Enclosed is the MFMA Flooring Inspection Report on the maple athletic floor system at the Dover High School in Dover, New Hampshire.

**MAPLE FLOORING MANUFACTURERS ASSOCIATION
DOVER HIGH SCHOOL
DOVER, NEW HAMPSHIRE
INSPECTOR: DANIEL F. HENEY
DATE OF INSPECTION: APRIL 4, 2019**

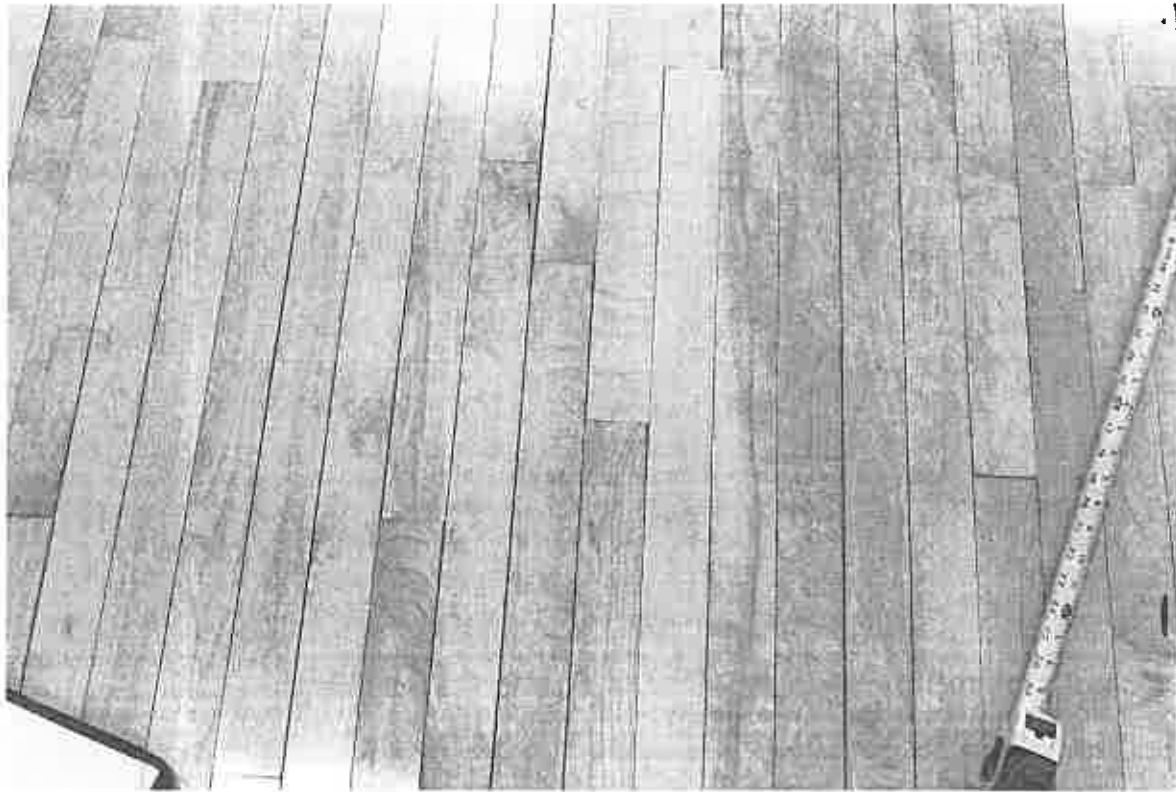
4. Facility officials indicated that shrinkage separation in the floor was a concern. Our inspector checked the floor for shrinkage separations and noted that they were present throughout the floor system.

Our inspector checked the moisture content levels in the maple flooring and recorded the environmental conditions in the gymnasium. Our inspector recorded moisture contents readings from four locations throughout the floor system. Our inspector found no measurable amount of moisture in the floor. The Delmhorst moisture meter used by our inspector cannot read moisture contents below 6%. Our inspector also recorded the environmental conditions within the gymnasium on the day of the inspection. The average temperature was 70.5 degrees Fahrenheit with a relative humidity level of 15.5%. According to the USDA, based on the temperature and relative humidity levels recorded on the day of our inspection the maple flooring at Dover High School should have a moisture content of 3.5%. That means the maple floor system at Dover High School may have been exposed to extremely dry indoor relative humidity conditions if conditions like those observed on the day of our inspection are representative of typical environmental conditions in the space. The unmeasurable low moisture content conditions of the maple flooring at Dover High School seems to indicate that the floor has been exposed to extremely dry conditions. According to the USDA, maple flooring in New Hampshire should have a moisture content range of 6%-12%. The low end of that range can be expected in the winter months and the high end of that range in the summer months.

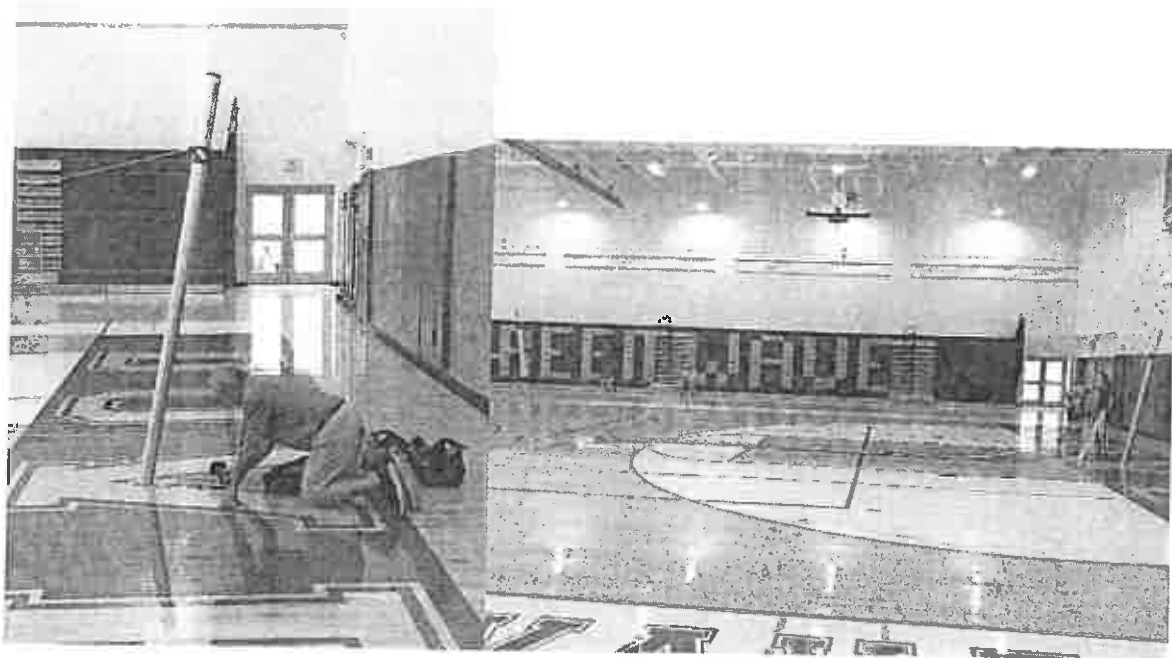
It is MFMA's opinion that there is reason to believe that humidity level differences have been in excess of 15% which has resulted in significant shrinkage. Wood is a hygroscopic material. When exposed to varying temperatures and humidities, it will release or absorb moisture until it is at equilibrium with the surrounding atmosphere.

The Maple Flooring Manufacturers Association (MFMA) recommends that the facility's environment be stable when the flooring materials arrive, during installation and after installation -- air temperature between 55 and 75 degrees and indoor relative humidity between 35 and 50 percent.
